**SANITARY DISTRICT NO. 5 OF MARIN COUNTY
2001 Paradise Drive
Tiburon, California 94920**

**Capital Improvement Program Committee Meeting
Tuesday, December 8th, 2020, 11:00 a.m.**

Project: Cove Road Sewer Rehab

Change Order No. 07

11 OF 20
 1" SCALE
 IF THIS DOES NOT MEASURE ONE INCH, THESE PLANS ARE NOT TO SCALE.
REVISED SET 11/02/2020

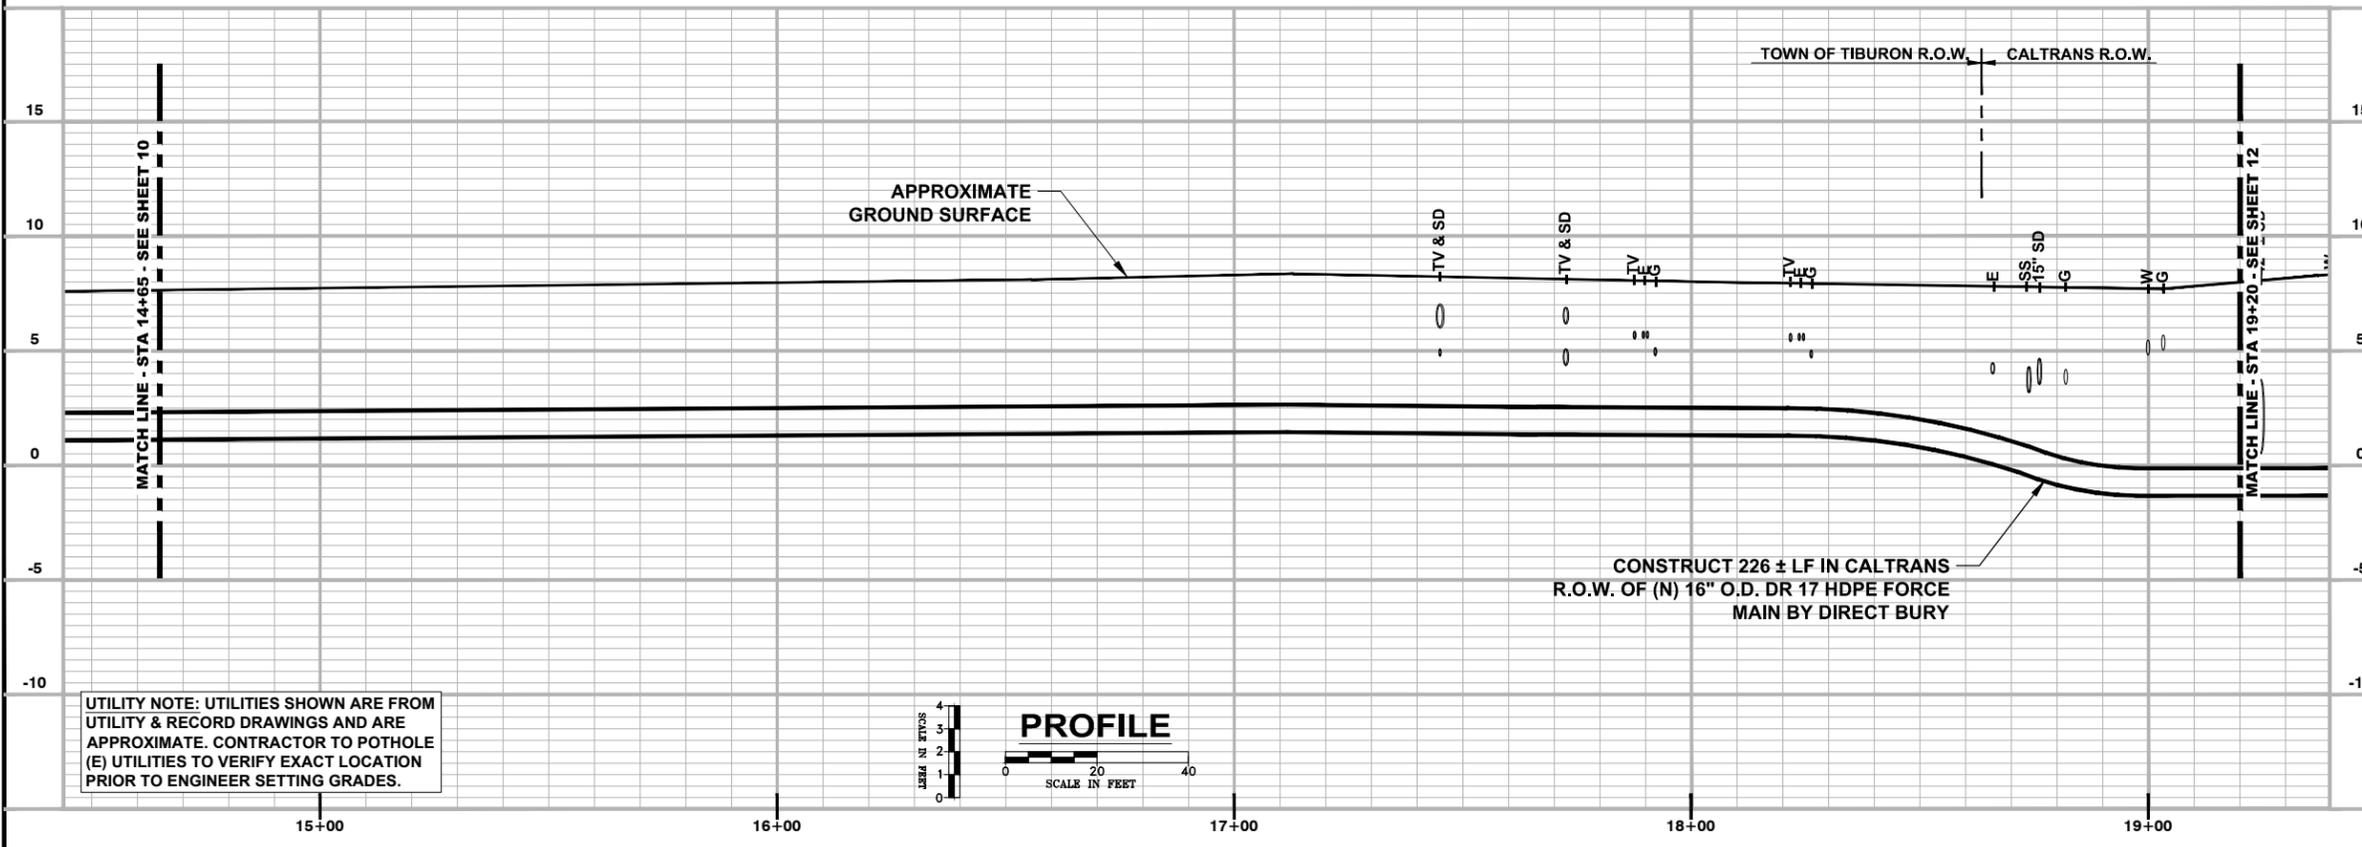
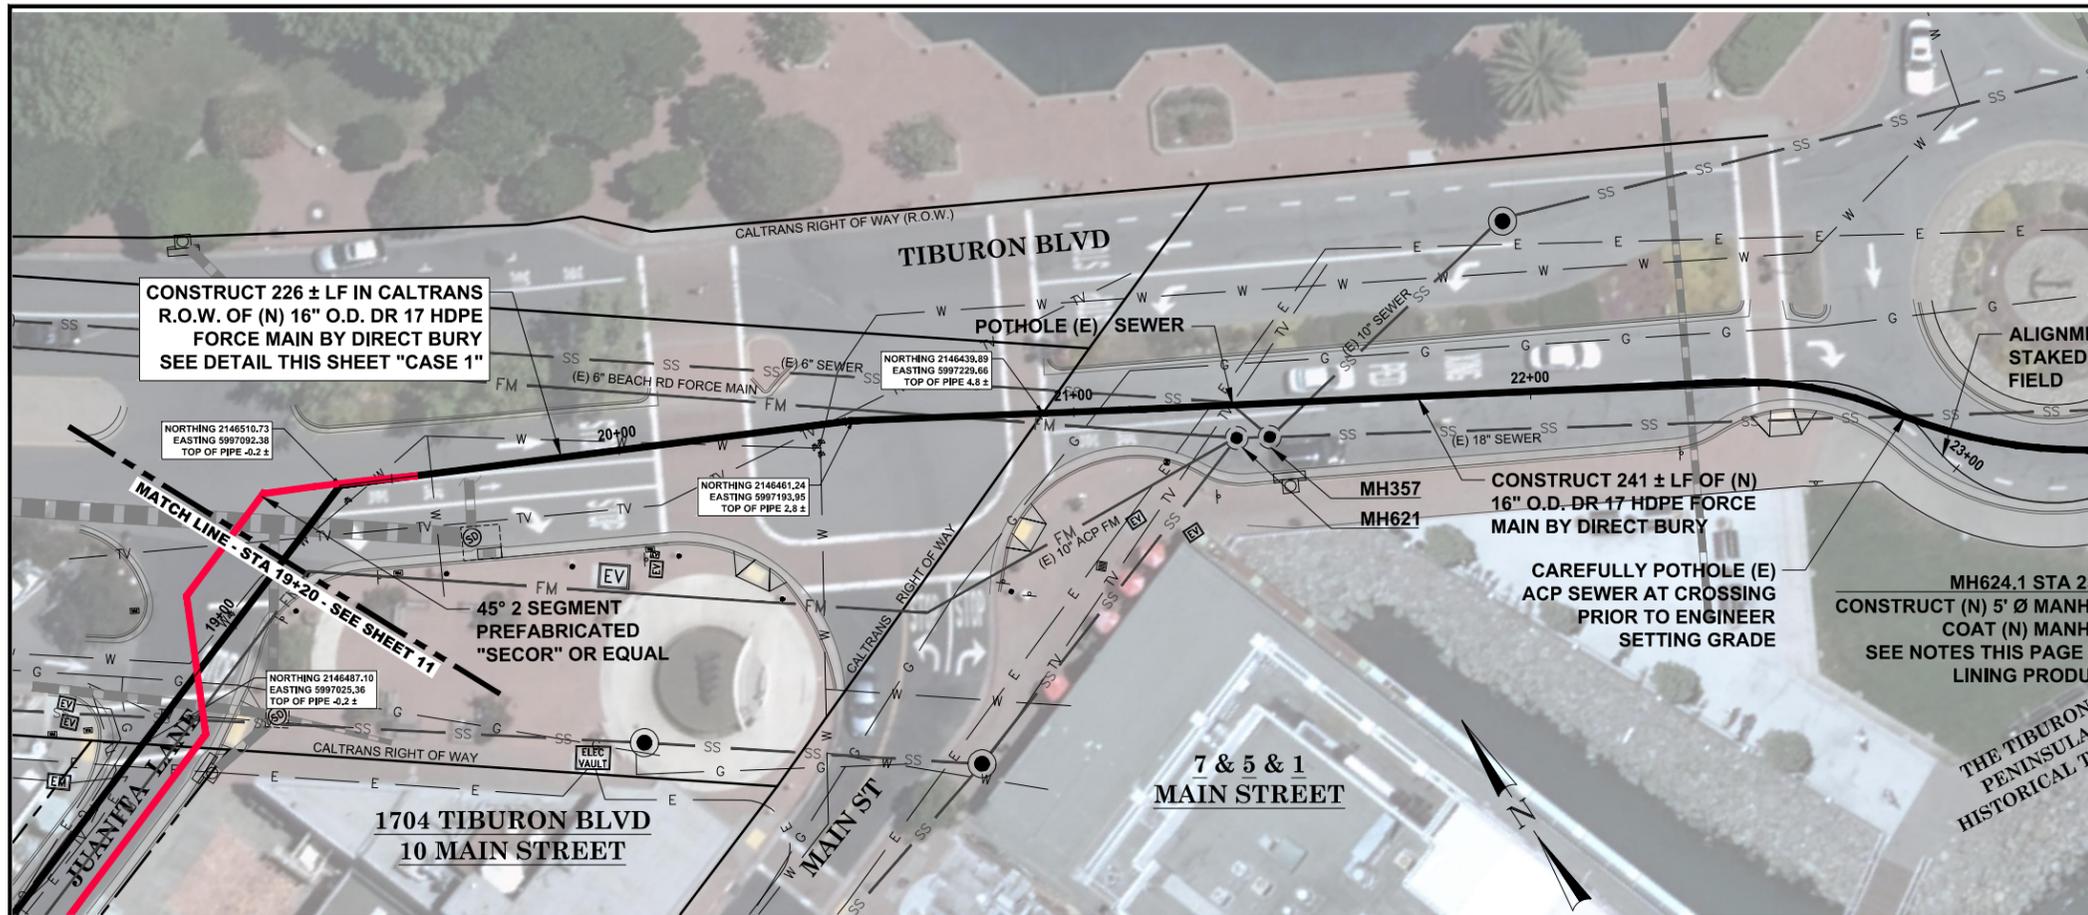
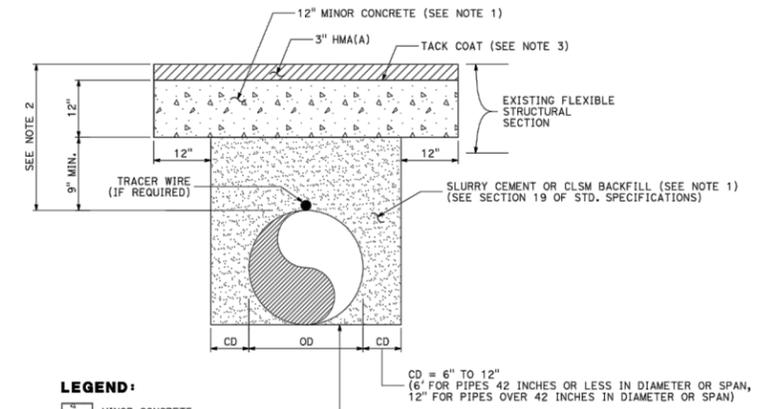
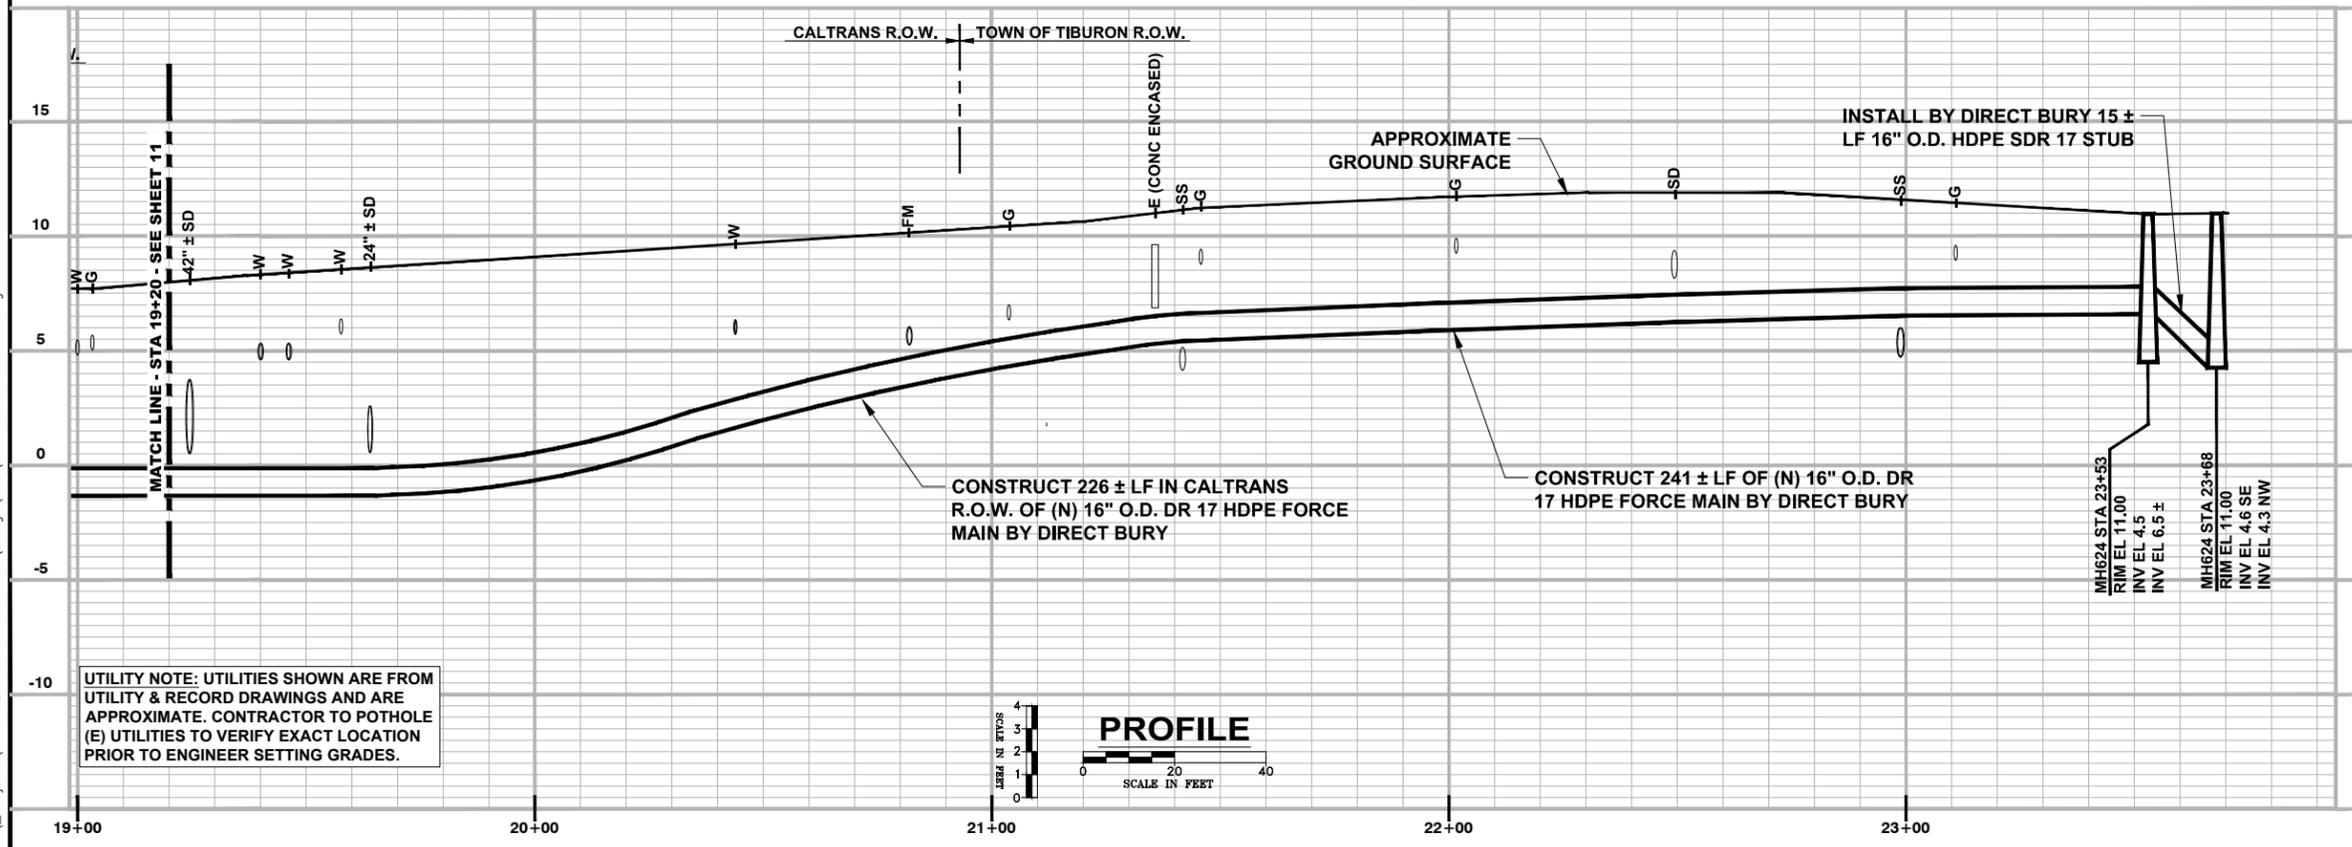
Adjust force main plan and profile per November 2, 2020 letter request (see attached Revised Sheets 11 and 12). The Contractor has provided a credit for various bid items per his attached spreadsheet.

Reason for Change: The attached November 2, 2020 letter from Nute Engineering, including Caltrans Encroachment Permit Rider dated October 27, 2020, modified force main construction requirements within the Caltrans ROW. In addition, the sewer profile required deepening at storm drain in Caltrans ROW.

Pricing Data: Pricing per attached email and filled in spreadsheet from Maggiora & Ghilotti dated November 4, 2020 for a credit of \$69,280.00.

13 OF 20

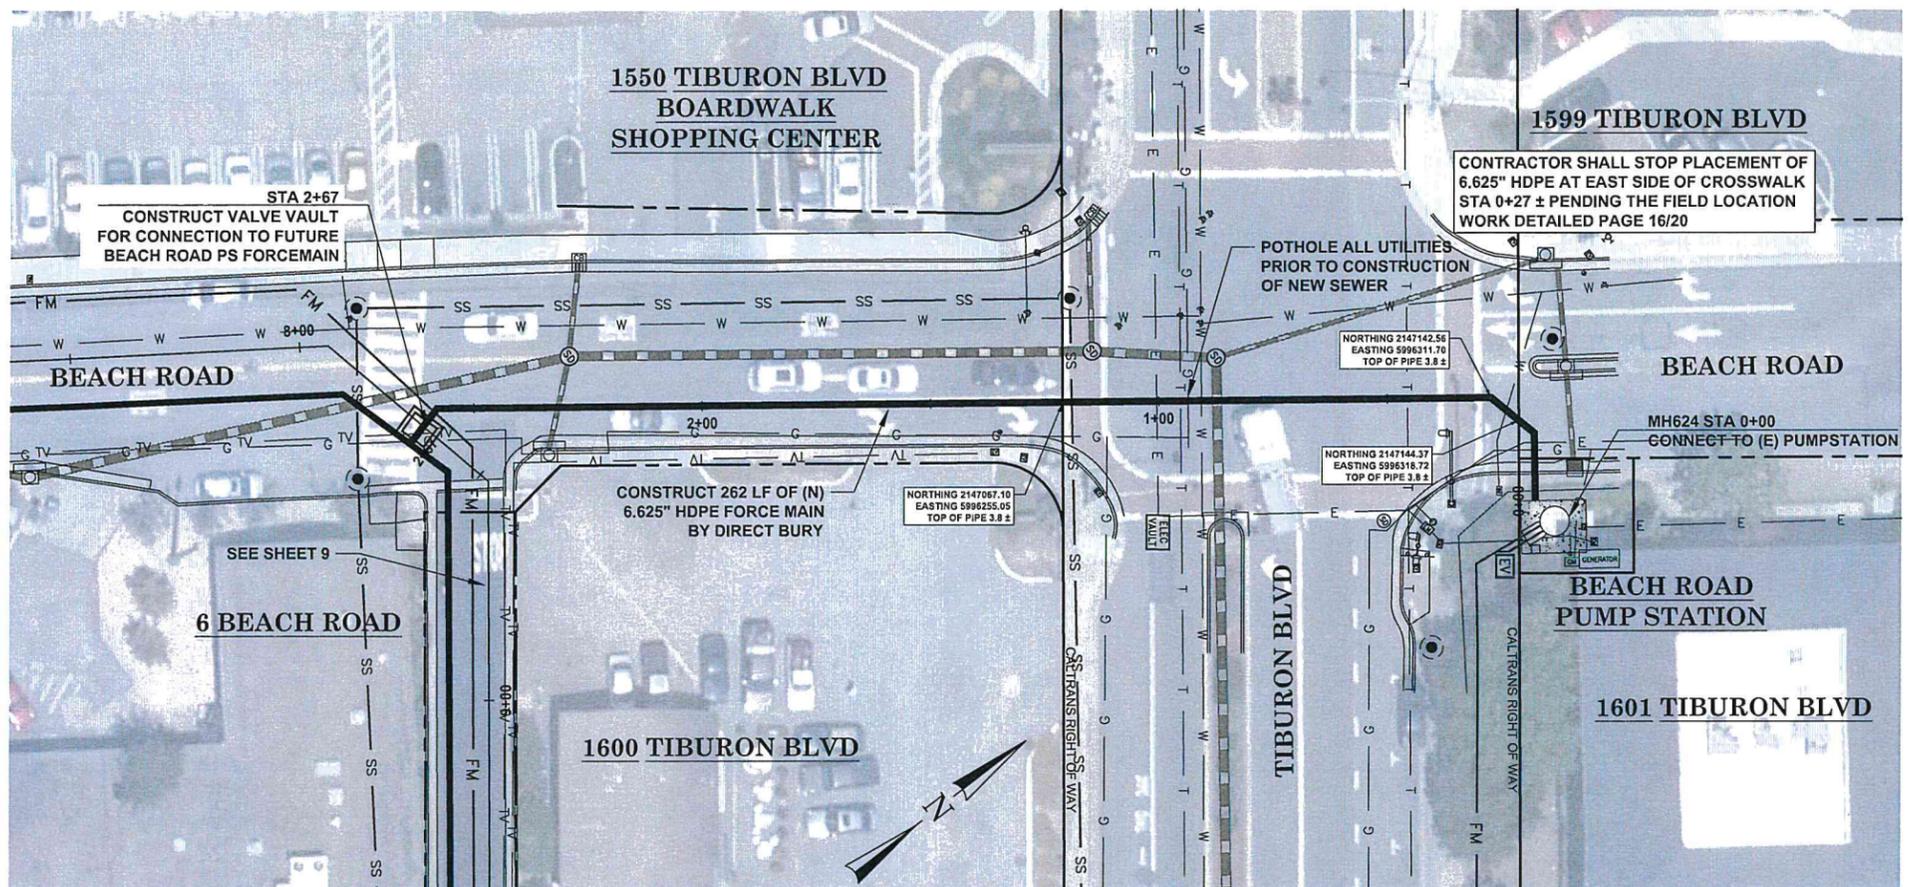
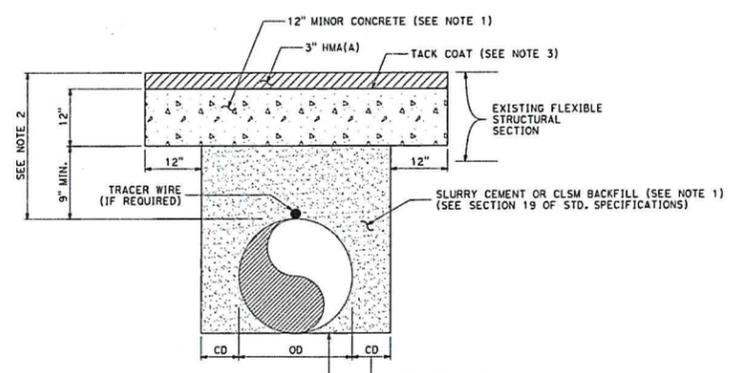
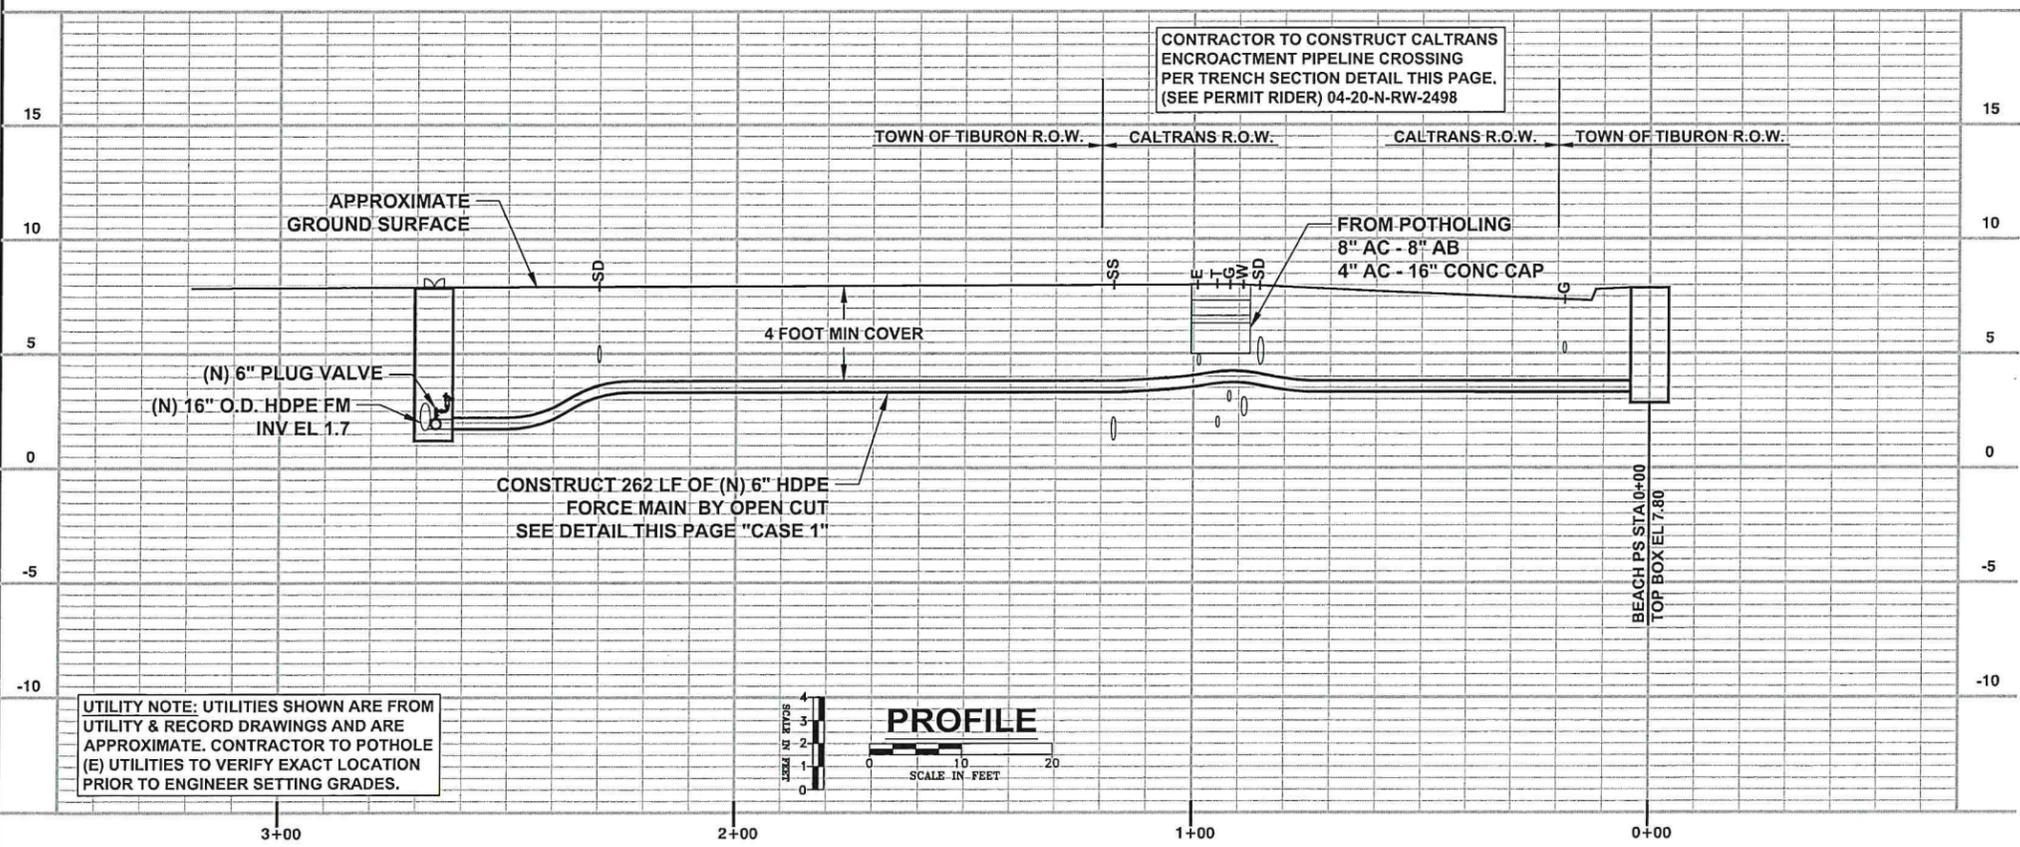
Adjust Beach Rd Pump Station force main plan and profile per November 2, 2020 letter request (see attached Revised Sheet 13). The Contractor has provided a credit for various bid items per his attached spreadsheet.

Reason for Change: The attached November 2, 2020 letter from Nute Engineering, including Caltrans Encroachment Permit Rider dated October 27, 2020, modified force main construction requirements within the Caltrans ROW. The modifications included substituting open cut construction of Beach Rd Pump Station force main and deletion of steel casing in lieu of contract Bore and Jack, Bid Item 11.

Pricing Data: Pricing per attached email and filled in spreadsheet from Maggiora & Ghilotti dated November 5, 2020 for a credit of \$22,931.00.

- Horizontal boring sub
- Purchase of 14" casing
- Welder
- Class 2 AB
- Pit excavation and shoring

- Caltrans detail for CLSM and minor concrete back fill
- Flaggers
- Purchase casing for under bricks with labor
- Restricted work hours 9:00AM - 3:00PM
- * Use bid item #18 to repave, 9 tons
